MFN 06-262
Supplement 4

Subject: **Modified Reactor Building/Fuel Building Truncated Model,
SER-ESB-038 Rev. 5**

**Shimizu Engineering Report SER-ESB-038, Rev. 5,
“Modified RBFB Truncated FE Model Analysis Data,”**

Project	General Electric Company ESBWR Project	Shimizu Document No.	SER-ESB-038
Title	Modified RBFB Truncated FE Model Analysis Data	Rev.	5
		Issued Date	9/22/06
		Revised Date	1/9/07

Figure 3-2 Hydrostatic Load Applied to the Spent Fuel Pool Walls and the Basemat

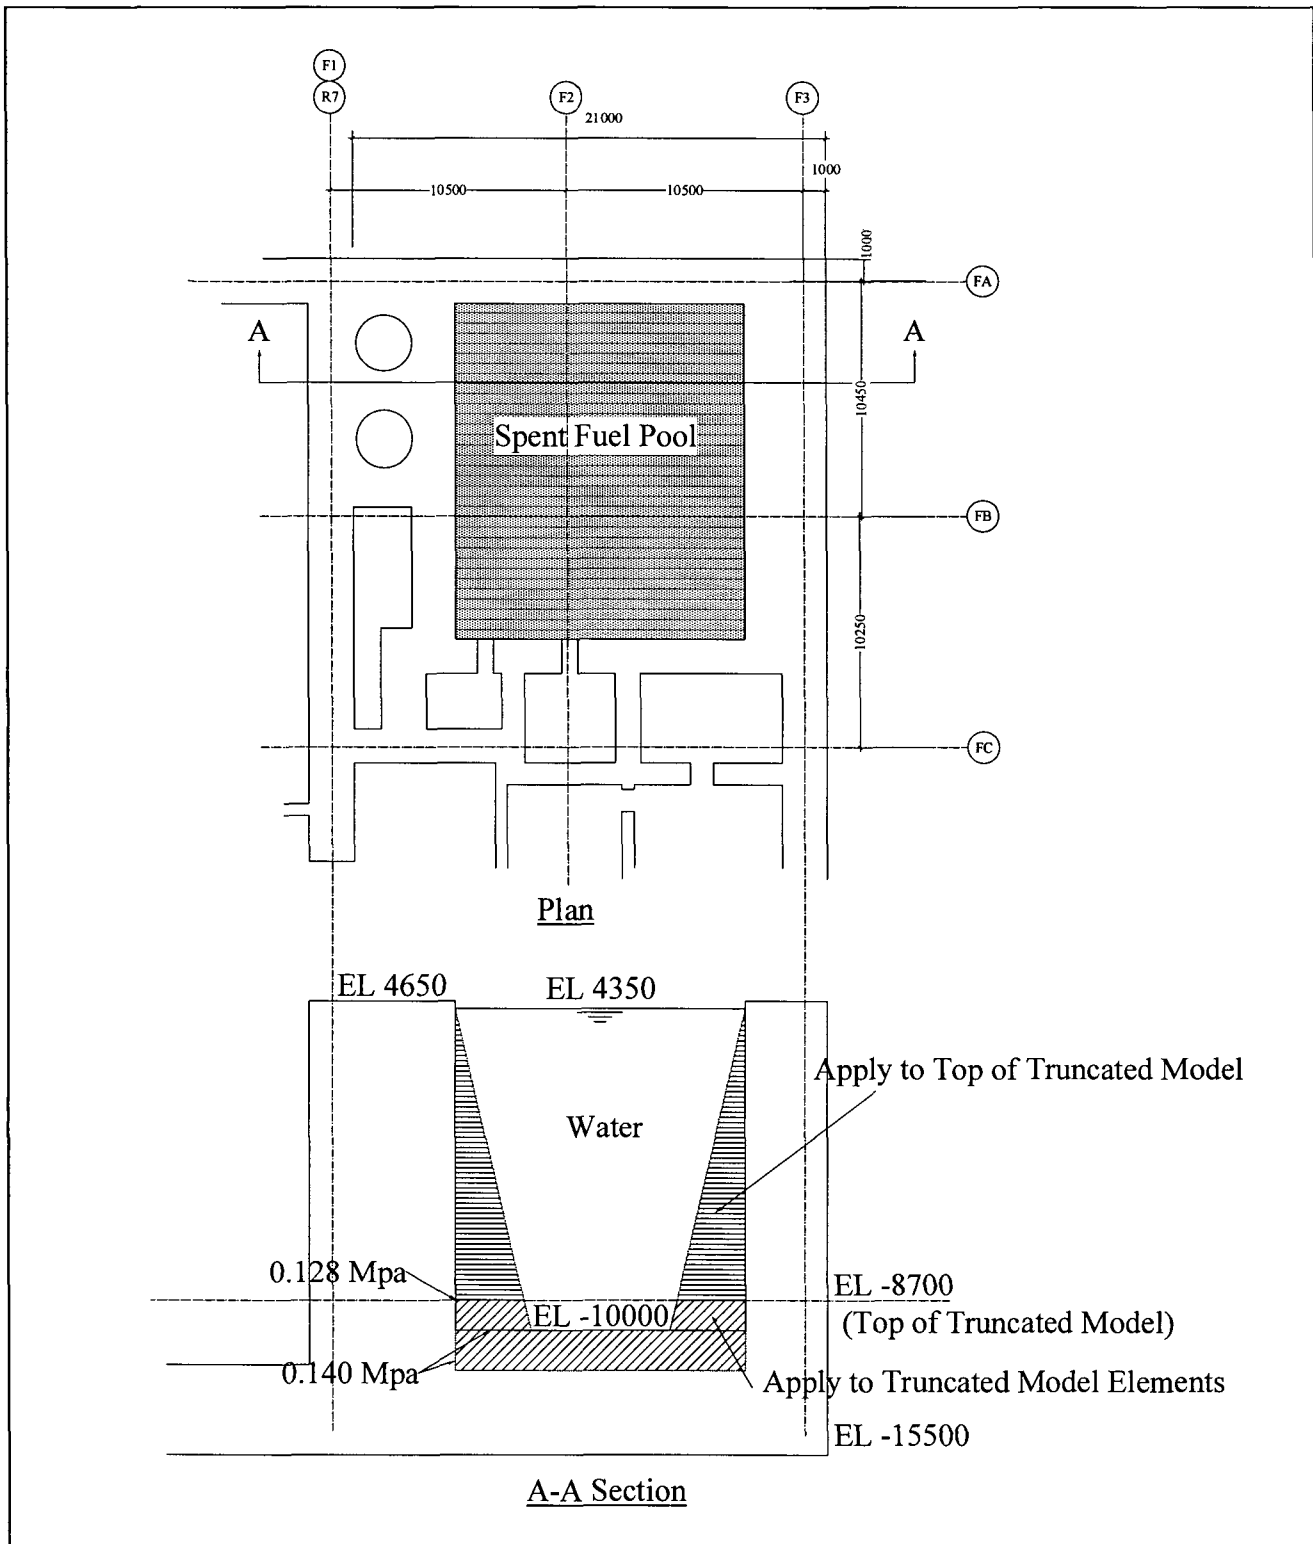
- The SFP pool gate gap was closed to meet the BNL's model.
- The plots of the force Nxy were added.
- The table which shows the relation NASTRAN element forces and BNL's that was added.
- The sketch of the direction of force on plane was provided.
- SFP wall (F3) model was offset to it' thickness center.
- The thickness of basemat inside RPV pedestal was changed from 4.0m to 5.1m.
- The hydrostatic load for SFP pool was modified to meet the BNL's analysis.

Hydrostatic load applied to the inside surfaces of Spent Fuel Pool walls and slab are shown in Figure 3-2. The boundary loads are calculated as shown in Table 3-23.

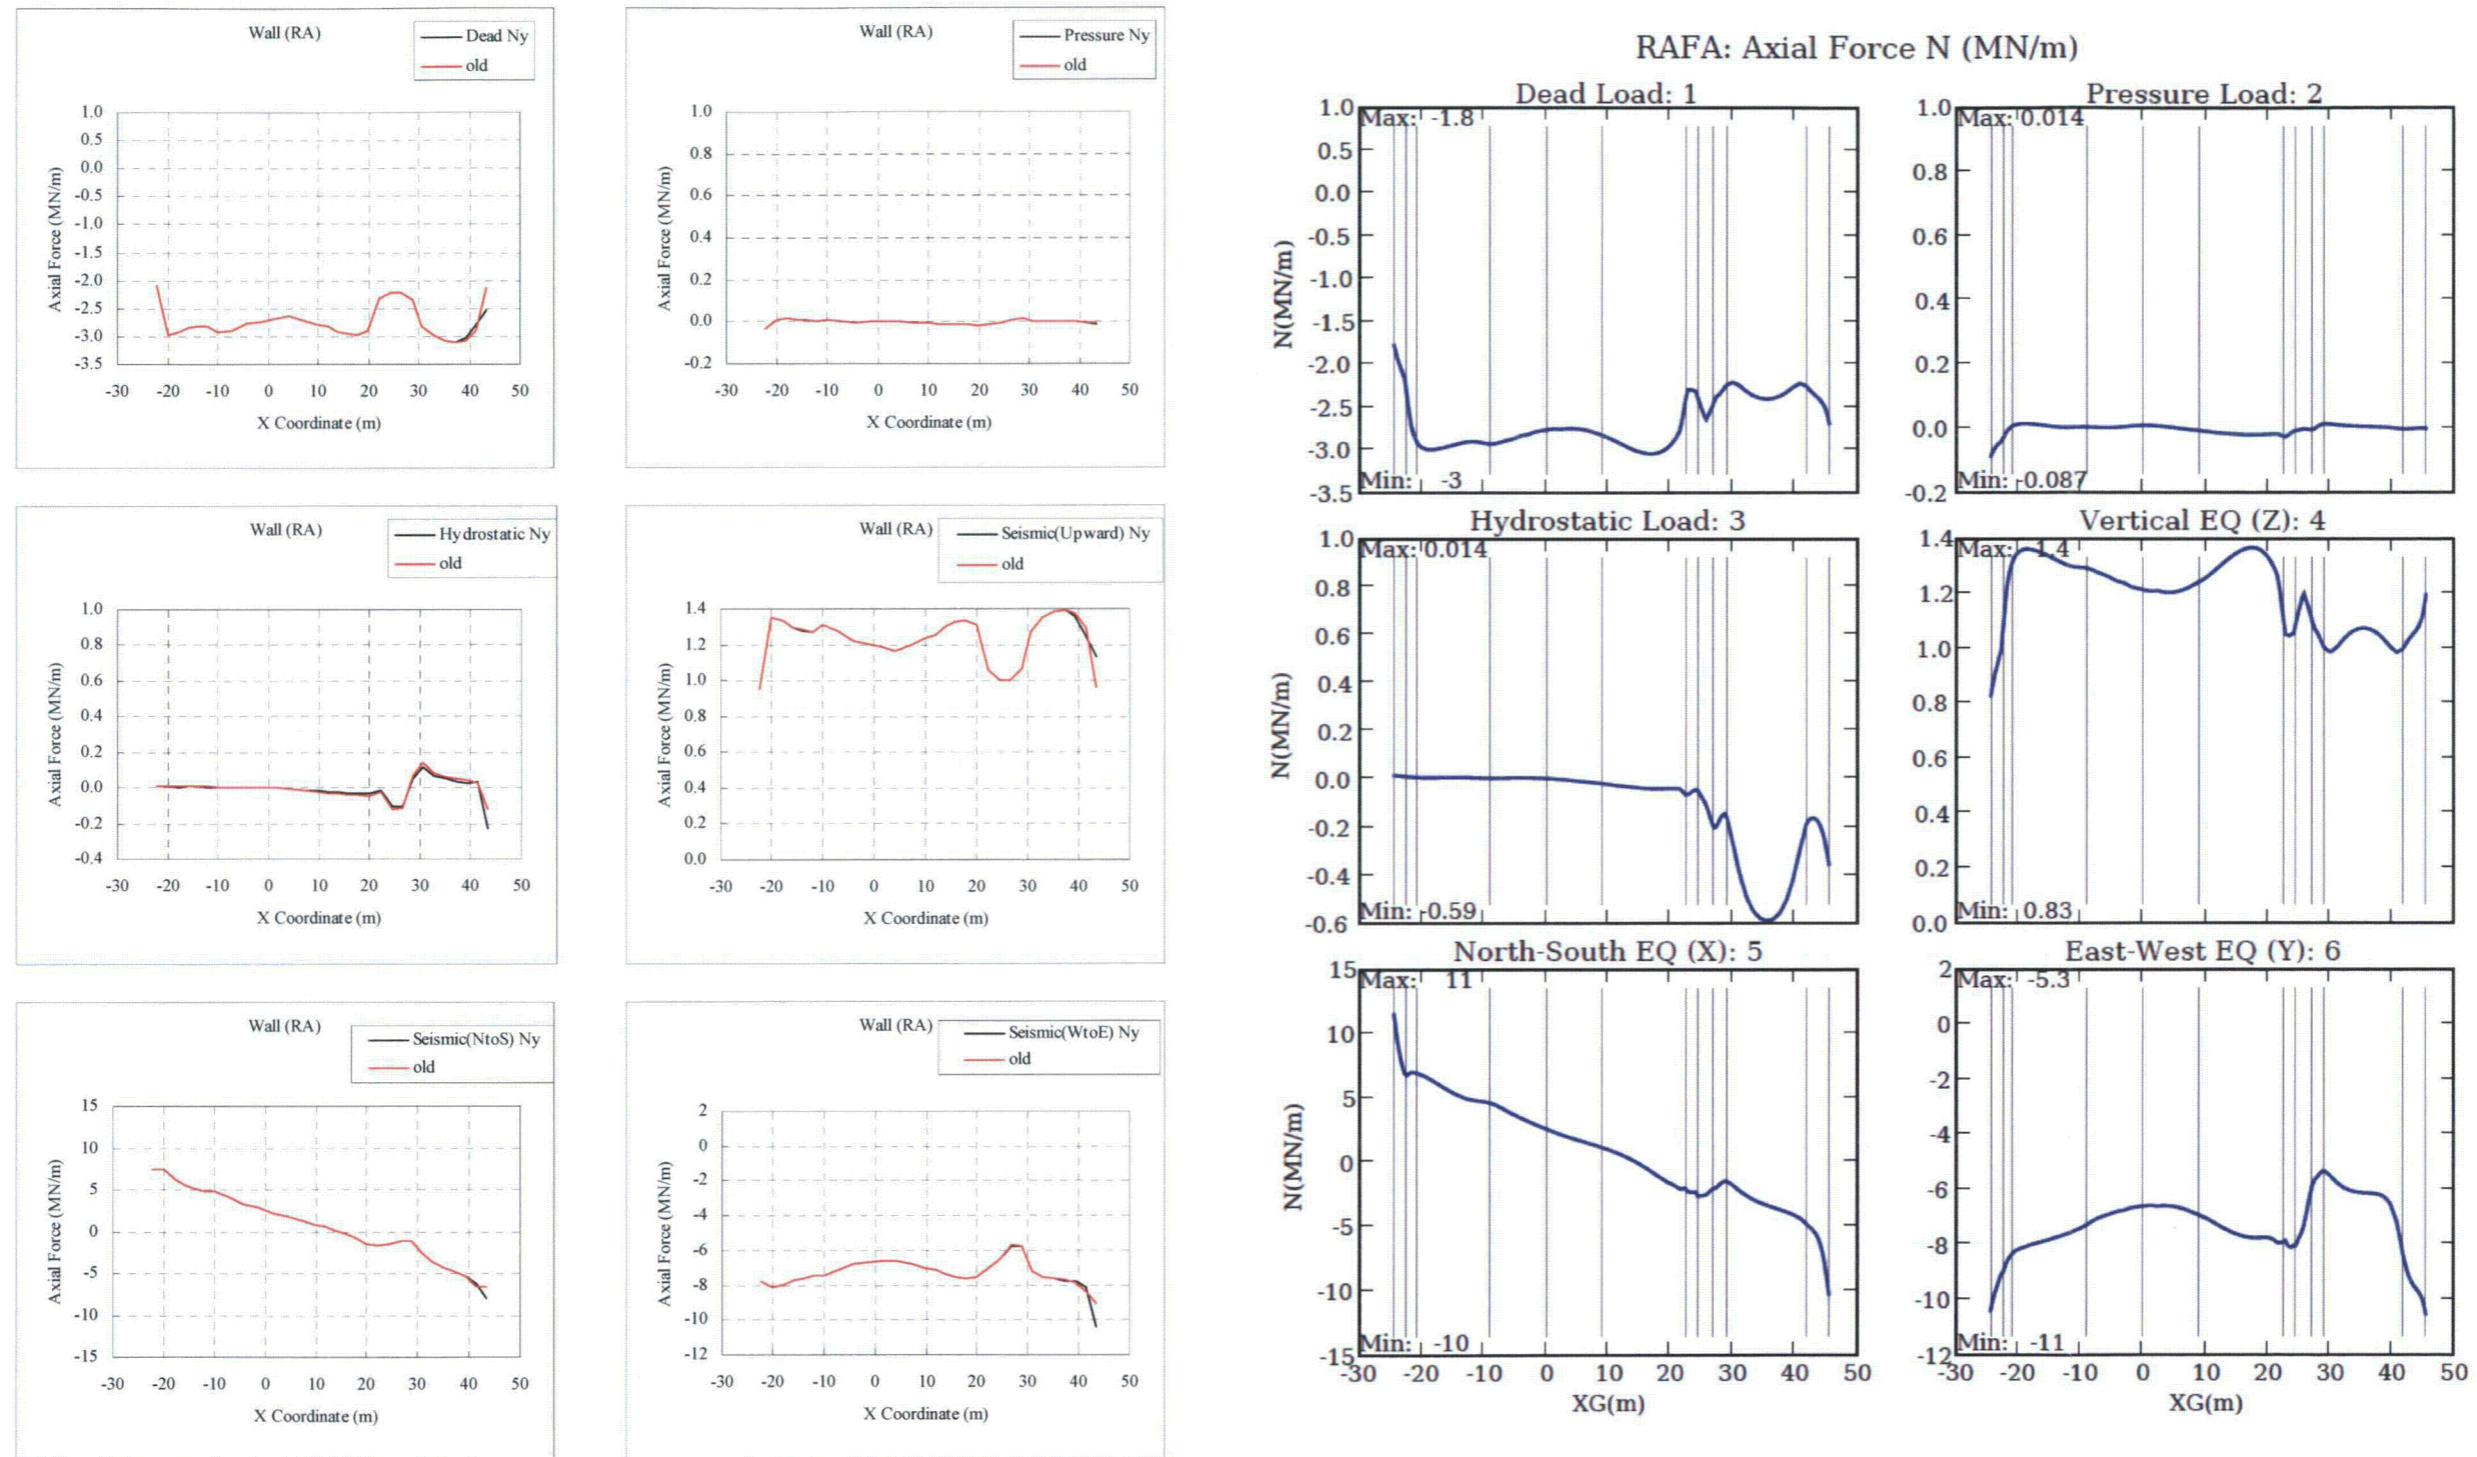
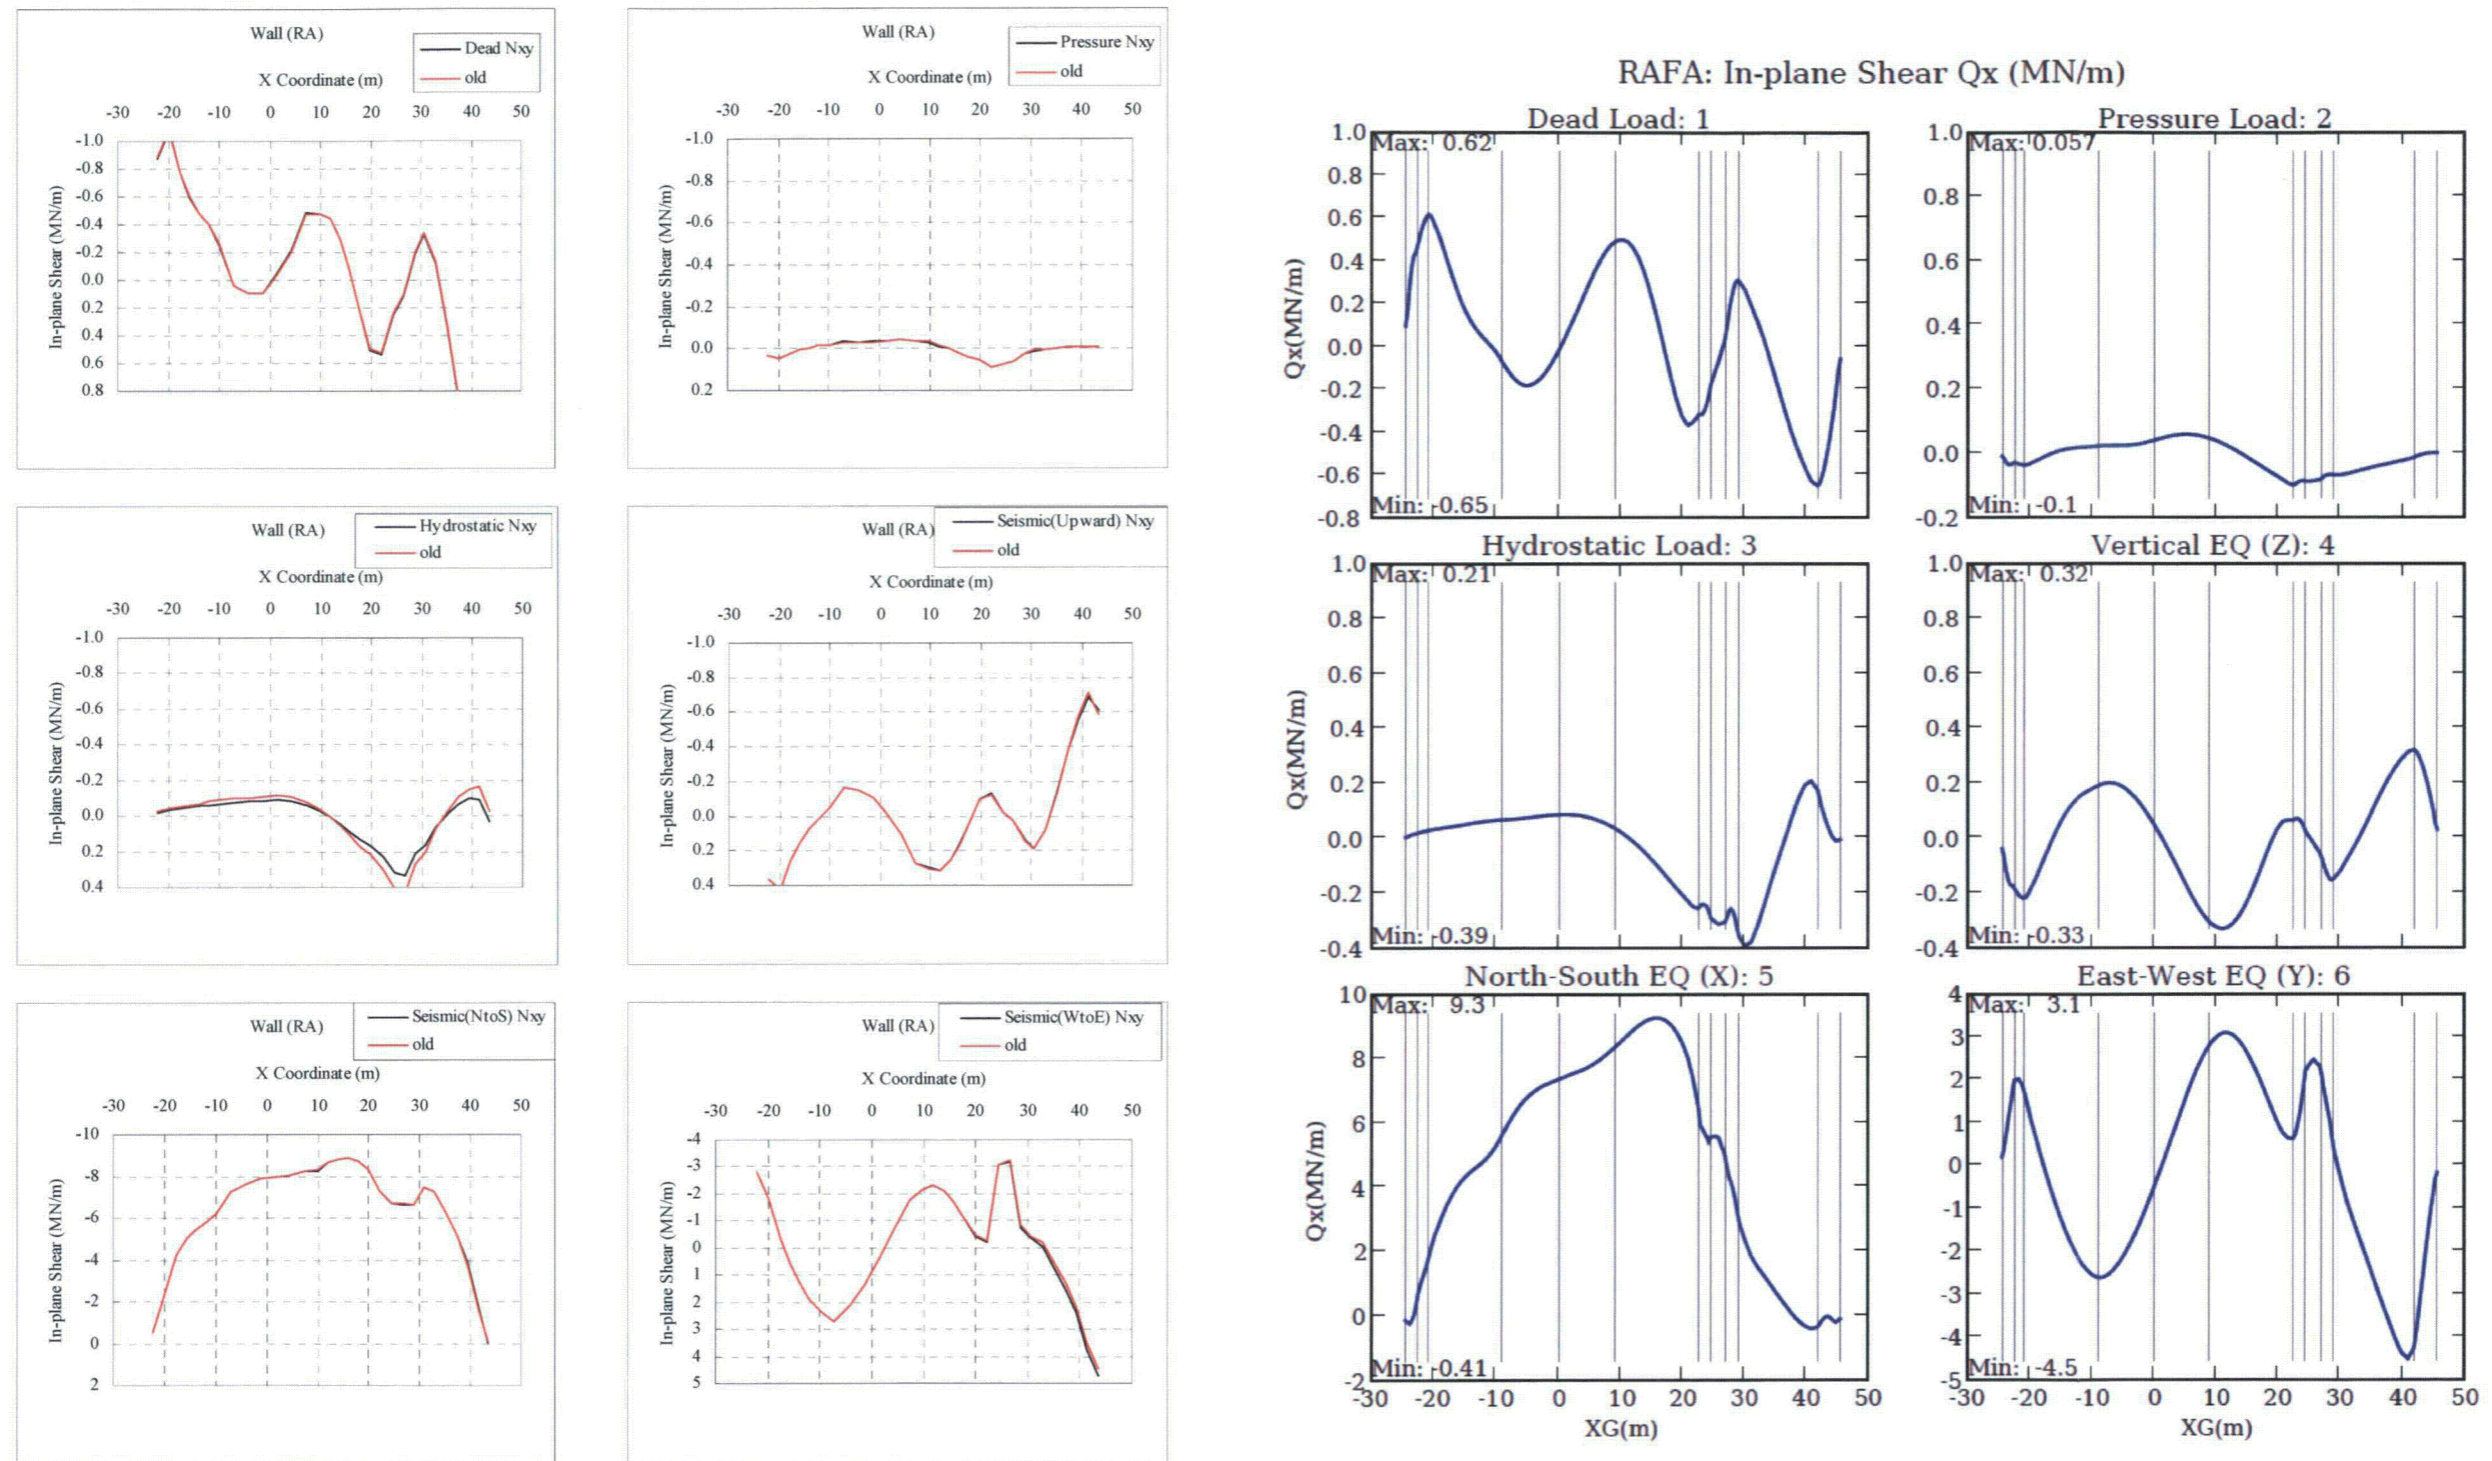
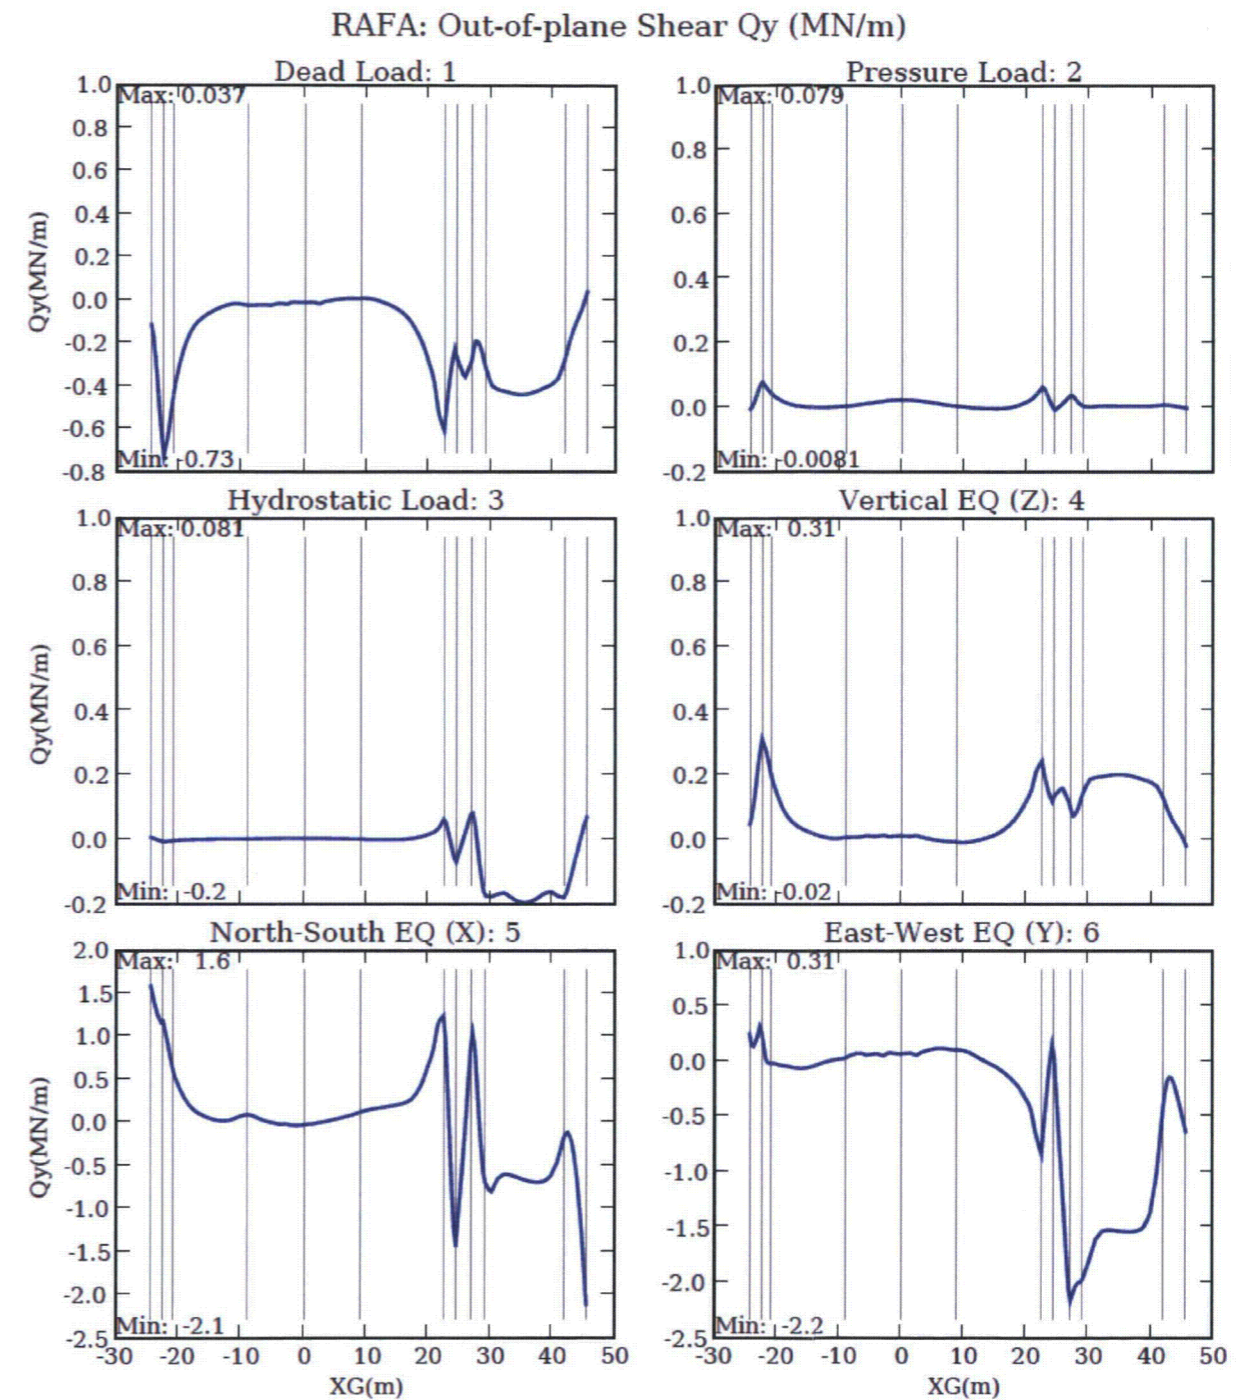
- iii) *The differences of magnitude of forces appeared on basemat inside pedestal:* The result of re-analysis using the updated model shows better agreement. In case of seismic load the magnitude of forces has to be re-compared because BNL's soil spring may not be adequate as pointed out above 3).

- iv) *The differences of magnitude of forces appeared on outer wall of Fuel Storage Pool (FSP):* For the out-of-plane shear forces and moments on RA and F3 wall located around FSP in case of Hydrostatic load, BNL's results are lower than those of GE. GE assumes the some part of differences comes from the difference of estimation levels between both models as pointed out above 8). In order to have a better understanding of the differences, GE would like to request BNL to confirm the input data for Hydrostatic load.
